LFWA Comments on Site Plan 820200200
Kensington of Bethesda at Westwood II

August 31, 2020

- **Green Roof Treatment Train**

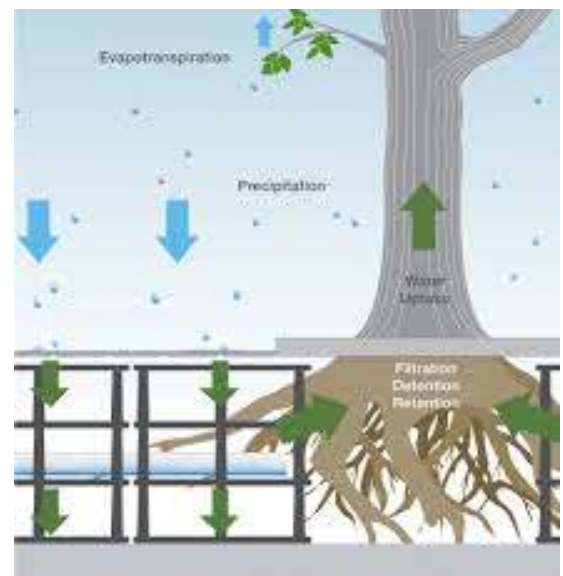
The stormwater management plans calls for 438 square feet of green roof. Although, a green roof is an excellent green technology and good for reducing the heat index and also reducing cooling and heating costs for the building, it does not allow the rain water to infiltrate the ground. However, the run-off from the green roof can be directed to one of the bioretentions. The applicant should be required to incorporate this into the roof drain plans. It would add much to the total volume, but in this site, every little bit is important.
